**ADDENDUM NO. 2**

April 28, 2026

William T. Keeton House North Wing Structural  
Repair & Water Infiltration Mitigation  
Addendum No. 2  
April 28, 2026  
Page 2

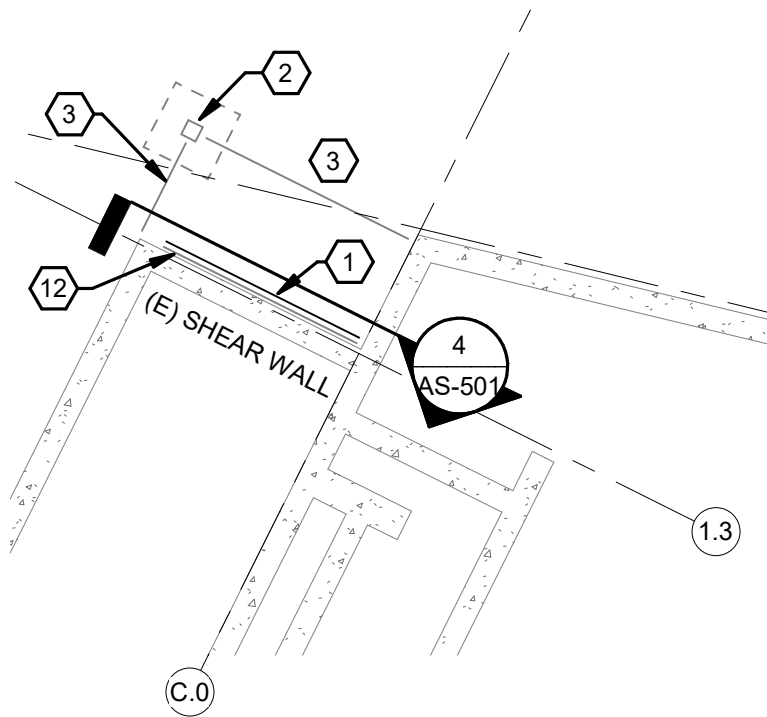
Item 4. **ADD** Sketch SSK-01, attached, with section mark indicating detail 4/AS-501 and detail line to represent existing angle.

5	AS-101 SSK-01		Please provide a Plan View detail showing where the new steel is being placed to confirm location. The Details are misleading.	See Addendum No. 2, Items 3 and 4.
6	AS-101 SSK-01		On AS-501 Detail 4 shows the new support on concrete wall. The way the detail is oriented with existing steel on right. Is this detail backwards.	See Addendum No. 2, Items 3 and 4.
7			In the renovation plans it asks to put back 2" solid block in wall under metal studs/track, are we removing solid blocks or any other material to replace with solid block.	The solid block is replacing the metal studs that likely go down to plank based on other existing conditions found in the building. Bottom of new studs will be higher than existing studs. Blocks will fill in that elevation difference.
8	AS-102		Drawing AS-102: Is the glazing listed applicable to this project?	Yes, match existing door and window size.
